Application for Works Approval Amendment

Works Approval Number	W5800/2015/1
Works Approval Holder	Opalvale Pty Ltd
ACN	106 512 896
File Number	DER2014/003195
Premises	Salt Valley Road Class II Landfill Chitty Road, HODDYS WELL WA 6566 Legal description – Part of Lot 11 on Deposited Plan 34937 Certificate of Title Volume 2535 Folio 391 As defined by the Premises maps attached to the Revised Works Approval
Date of Report	24 February 2022
Decision	Revised works approval granted

Works Approval: W5800/2015/1

Figure 1: Proposed site layout

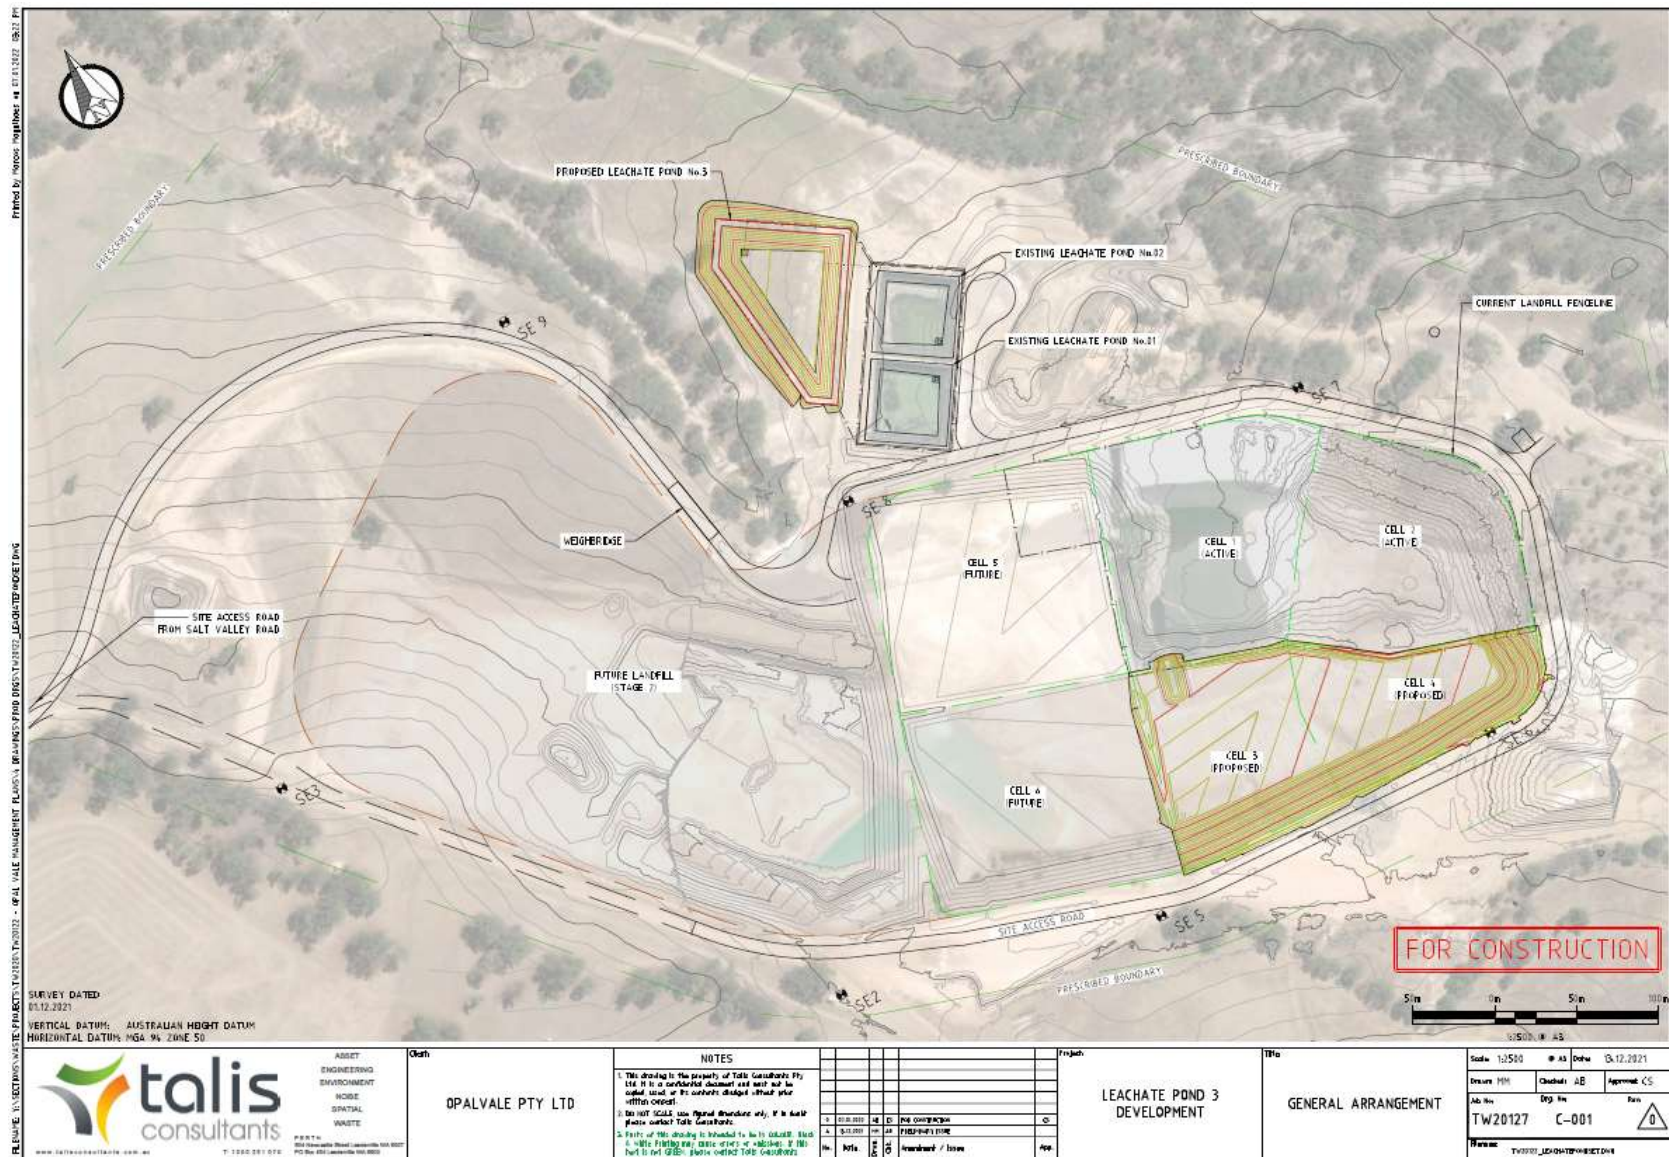
The Works Approval Holder is proposing to amend the previously approved Stage 1 landfill design so that individual Cells 3 and 4 are constructed as a single cell. The Works Approval Holder has advised that due to the small size of Cells 3 and 4, it will be more efficient to construct them together.

It is also proposed to install a separate leachate extraction system for the new cell as opposed to relying on the existing extraction system within Cell 1, as this will allow for greater control of leachate levels on the landfill base.

Construction works and design specifications for the new cell will be consistent with what has previously been approved for Stage 1 landfill cells. The cell will be comprised of the following infrastructure:

- 500mm thick Engineered Attenuation Layer subbase, compacted to achieve a permeability of 5×10^{-7} m/s, which will be moisture conditioned in preparation for the liner system;

- Geosynthetic composite liner system, consisting of a geosynthetic clay liner (GCL) with a design hydraulic conductivity of $\leq 5 \times 10^{-11}$ m/s, a 2 mm thick High Density Polyethylene (HDPE) liner, a geotextile cushion layer, a leachate collection layer (including collection pipes and 300mm high permeability low calcareous aggregate) and a geotextile separation layer;

- Leachate collection pipework consisting of 250mm HDPE perforated primary pipework, and 110mm HDPE perforated secondary pipework;
- Leachate extraction and transmission infrastructure comprising of 355mm HDPE double side rise pipes, a 160mm HDPE leachate monitoring pipe, side riser concrete headwall and pump control cubicle, 110mm HDPE leachate main and rodding points.

The liner system will be integrated with existing cells and the landfill perimeter fence will be re-established around the new boundary to also include the new cell. The new cell design is outlined in Figure 1 below.

Based on these findings, the Works Approval Holder is now seeking the construction of one additional leachate pond with a triangular shape, which has been determined to be more appropriate to prevent impacts to natural drainage lines and maintain the required offset to groundwater. The new pond is proposed to be constructed to the following specifications:

- Side slopes at a grade of 1V:3H, reduced from 1V:2H in the previous design to provide better long term stability;
- Operational capacity of 11,370m³, accounting for the maintenance of a 500mm freeboard, an increase of 1,322m³ from the previous design of two square ponds;
- 250mm thick compacted subgrade layer;
- Installation of a geosynthetic clay liner or similar; and
- Installation of a 2mm double textured HDPE Geomembrane liner.

The location of this pond is outlined in Figure 1.

- The liner system proposed for the new leachate pond is the same as in use in currently operational leachate ponds 1 and 2, and the same as proposed in the original designs for 2 additional leachate ponds;
- The new shape and location of the leachate pond will negate the need for terracing ponds down the sloping ground in the area of construction and will ensure greater consistency across the pond area in maintaining an adequate separation distance to groundwater;
- Side slope stability should be greater in the new pond due to a reduction in side slope gradient from the original designs; and
- The leachate pond will have a greater holding capacity than previously proposed for the two additional leachate ponds.

Figure 2: Bore location surrounding landfill footprint

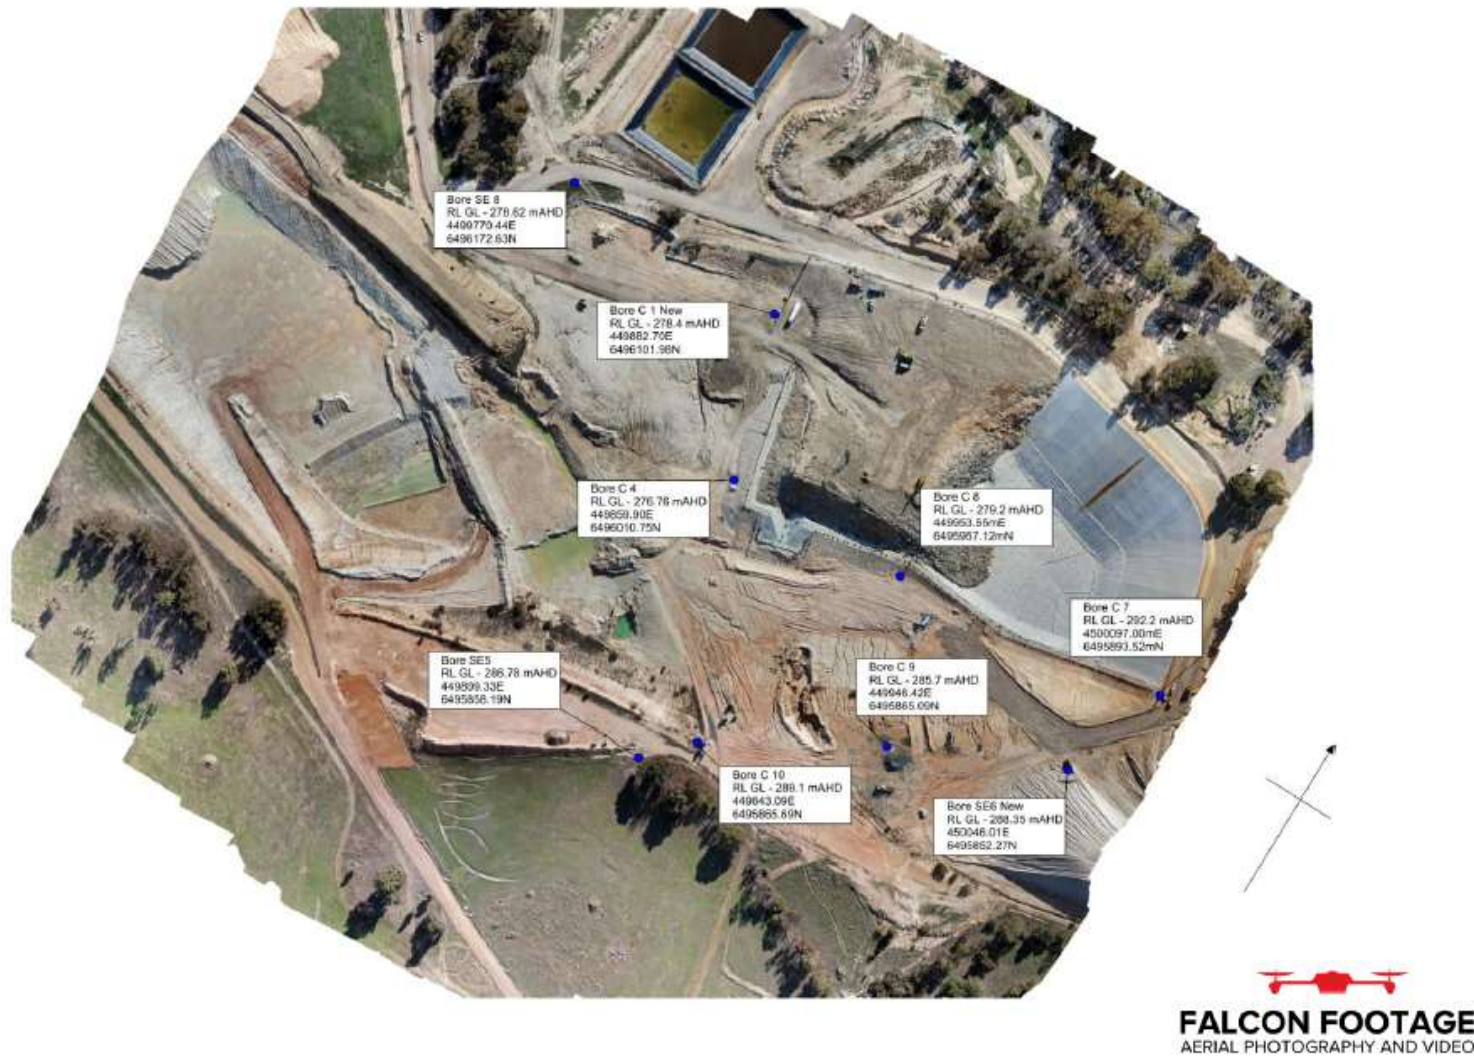
There are currently three groundwater monitoring bores within the proposed footprint of the new landfill cells. To facilitate construction, these bores are proposed to be decommissioned by the Works Approval Holder in line with the guidance in the Water Quality Protection Guidelines No. 4 - Mining and Mineral Processing - Installation of Mine Site Groundwater Monitoring Bores 2000 Section 4.15. The bores requiring decommissioning are bores C7, C8 and C9 as indicated in Figure 2 below.

To demonstrate compliance with these conditions within the existing works approval, the Works Approval Holder has commissioned Stass Environmental to undertake groundwater bore installation and monitoring in accordance with the specifications in the works approval. The results of this monitoring have been used to inform the proposed cell construction designs as discussed in Section 2.3.4 below.
